**REQUEST FOR
CONDITIONAL LETTER OF MAP REVISION**

**UNNAMED TRIBUTARY TO
BLACK SQUIRREL CREEK,
FALCON OWL PLACE**

FEMA COMMENT RESPONSES

**Subject: Falcon Owl Place CLOMR Application, Case No. 22-08-0669R
Response to FEMA A.D. Request dated August 19, 2022**

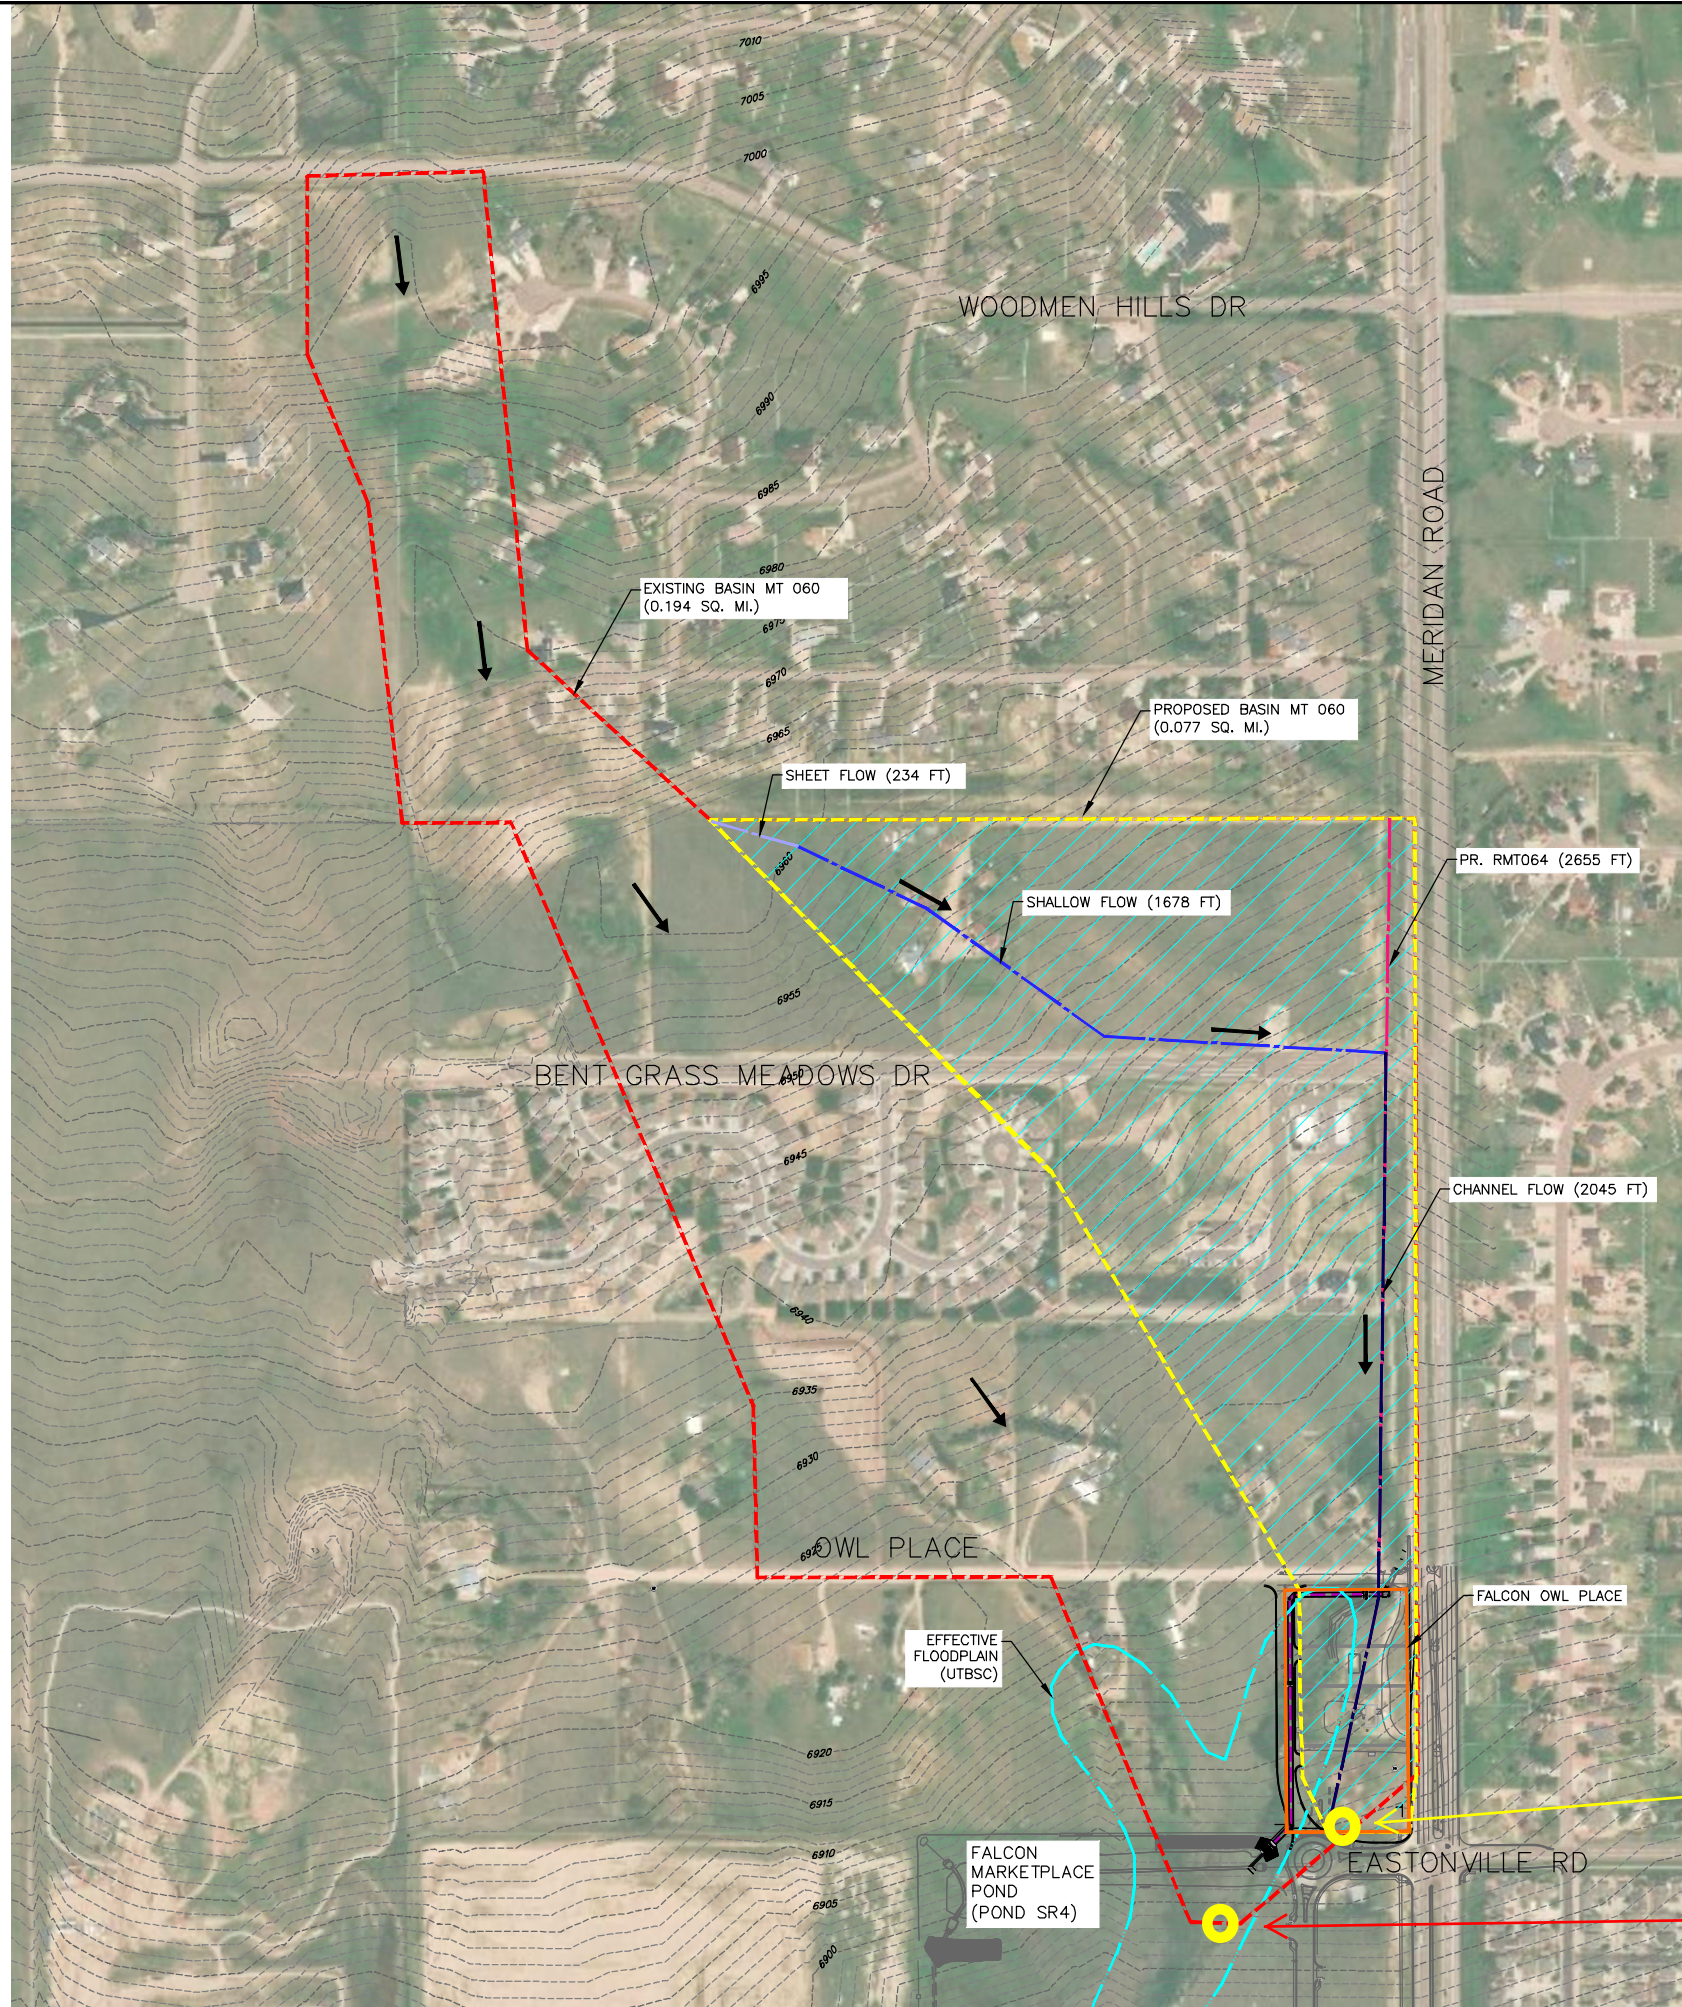
- c. Our review of the certified drainage area map revealed that the sub basins do not appear to be supported by the topographic contours included. Please provide a revised drainage area map that clearly follows contours and is smooth.

The topographic contours provide a general direction of surface flow. However, there are streets, culverts, and storm drainage infrastructure that informed the proposed basin delineation (in addition to the contours). In addition, the existing basin delineation for MT060 was taken from the Falcon DBPS. Notes have been added to the DA map for clarity.

Crossing - Existing Owl Place, Design Discharge - 920.0 cfs

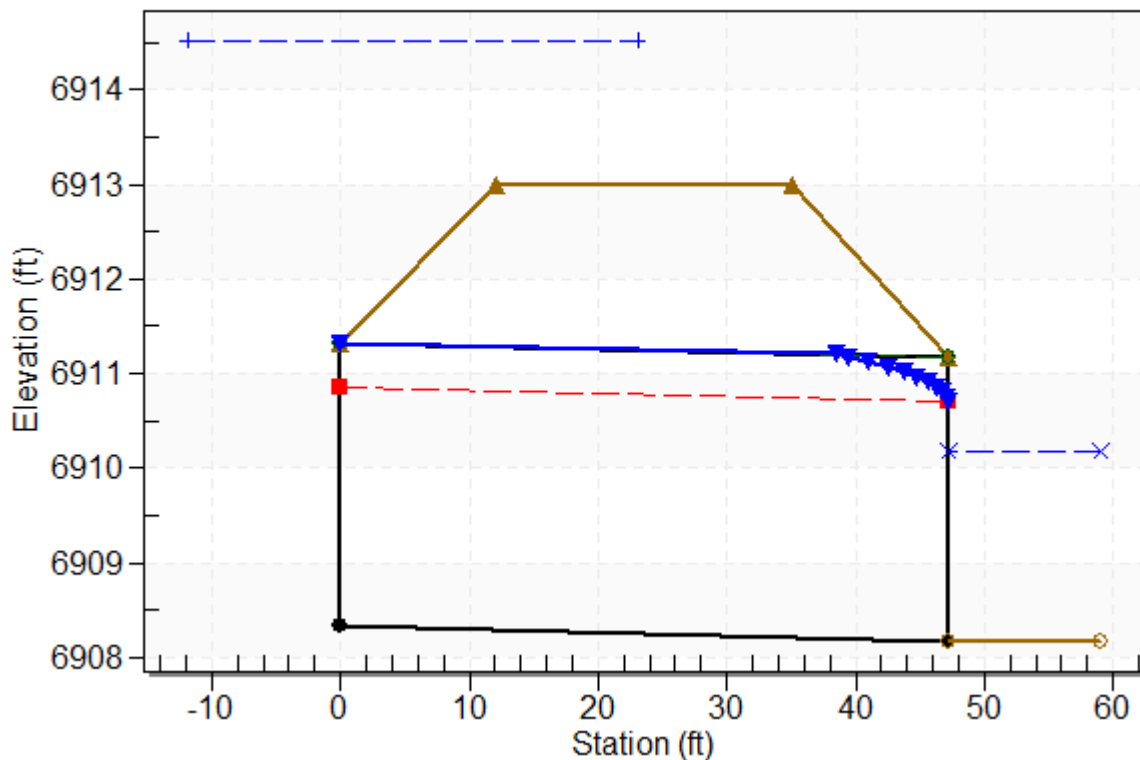
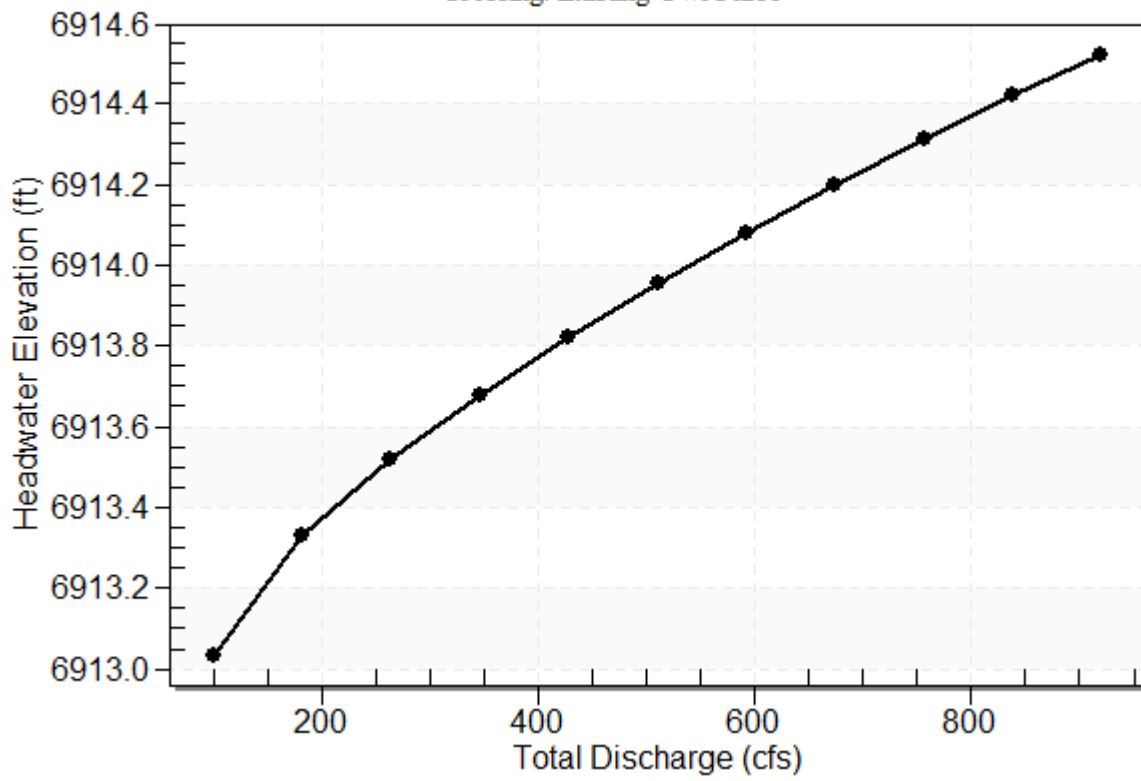
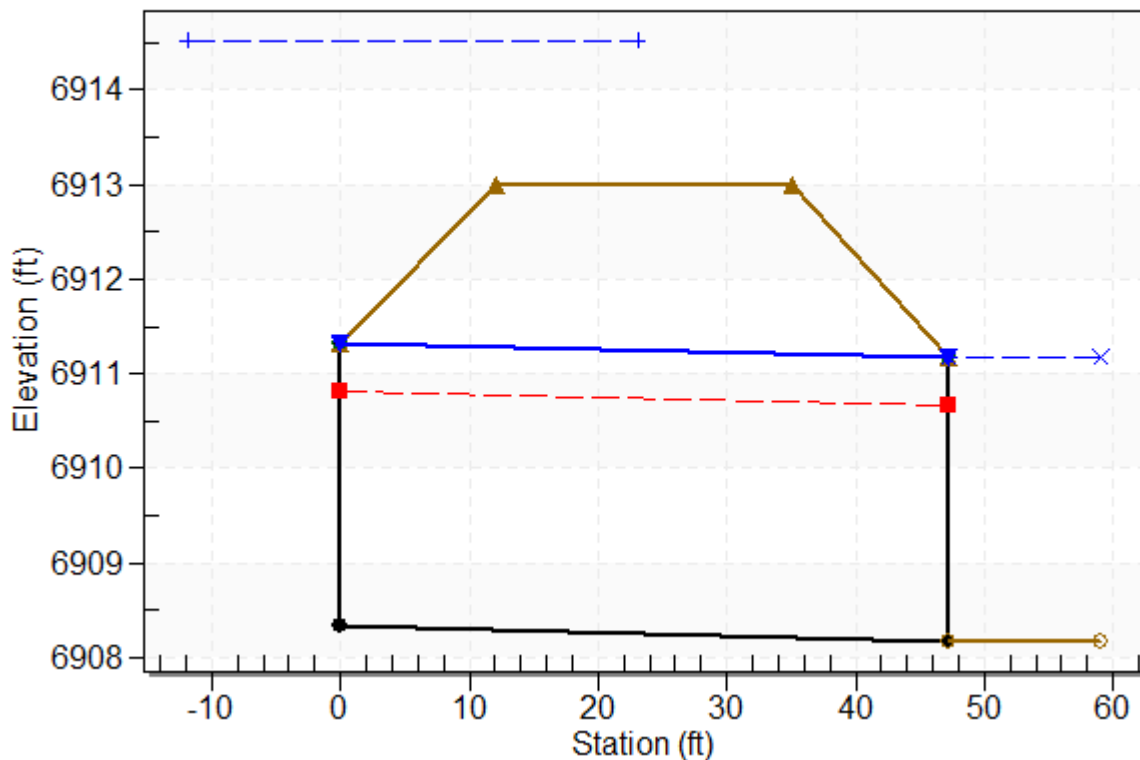
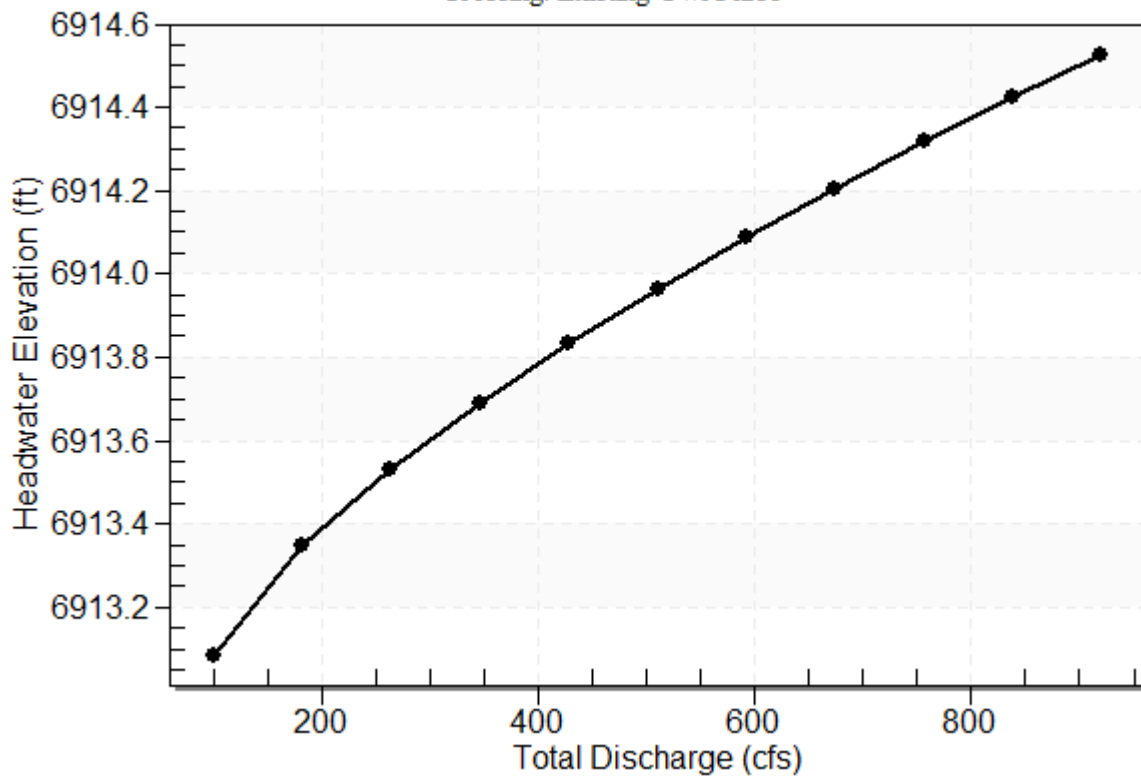
2. Our review of the submitted existing conditions HY-8 hydraulic analysis for the Owl Place culvert revealed the following issues. Please submit a revised analysis that corrects the following.

- a. Please adjust the model to calculate results for a design flow of 920 cubic feet per second (cfs).

- b. Please provide supporting documentation verifying that the overtopped flow from the Owl Place culvert is fully captured in the proposed junction box. If it is determined that the flood waters are not captured in the junction box, please provide a floodplain analysis and subsequent floodplain delineation that follows the corresponding flow path. The modeling of the Owl Place culvert in the submitted existing conditions HY-8 model does not agree with the submitted as-built drawings for the culvert. Our review revealed the culvert length shown on the submitted proposed plans entitled, "Pipe System Exhibit," prepared by Drexel, Barrell

& Co., dated June 2022, is 47.2 feet, but the HY-8 models the Outlet Station is 50 feet. Please adjust the outlet station to be consistent with the as-built plans.

- c. Please show the vertical datum, North American Vertical Datum of 1988 (NAVD88), in the description box of the HY-8 model or provide a statement certifying the datum of this model.

The HY-8 model was adjusted to include the design flow of 920 cfs.

The culvert was extended further upstream under Owl Place to ensure that the floodplain is contained through the crossing and within the roadside ditch along Meridian Drive.

The vertical datum was added to the HY-8 model.
